22 December 2011

**S.75W MODIFICATION TO MP10_0057 – RESPONSE TO ISSUES
132-138 KILLEATON ST, ST IVES**

Figure 1: Diagram showing resident access (red arrows) and communal facilities access (purple arrows)

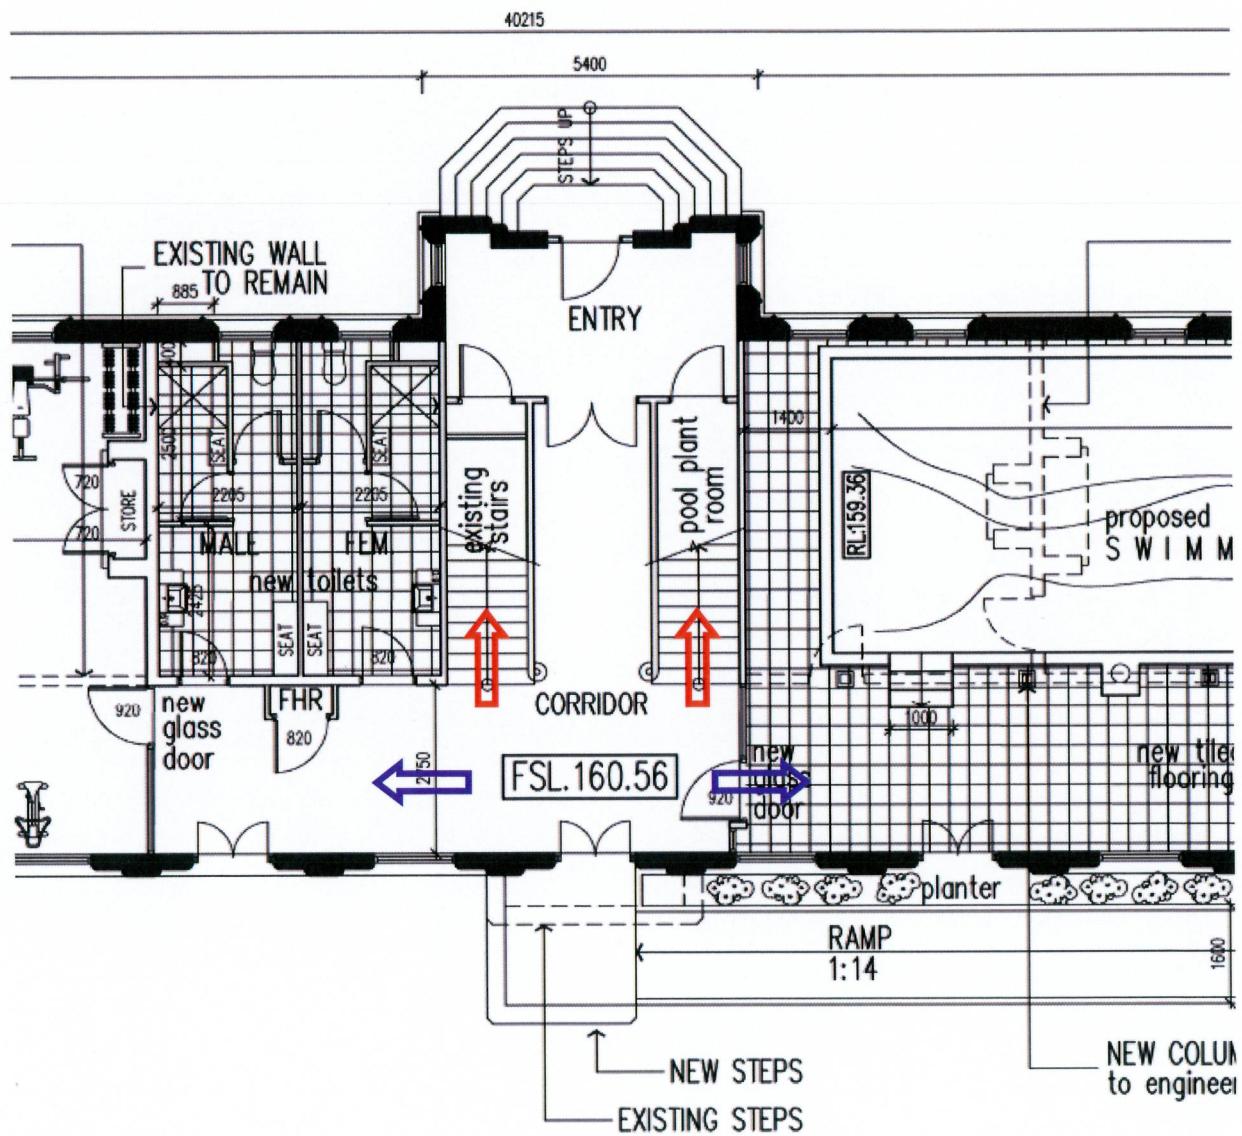
- *Details of how the proposed four units in the monastery building are to be accessed by residents and visitors. i.e. Is the residential access shared with the access to the community facilities?*

The ground floor level of the monastery building is to include a security entrance with intercom. Controlled access will be available to visitors. The entrance will be shared by residents who will have keypass access into the communal facilities on ground floor level.

Residents will approach their upper floor level communal lobby by climbing the stairs, which are being retained as part of the original building fabric. This ensures that the proposed units do not directly share the same lobby as that which provides access to the gym and pool.
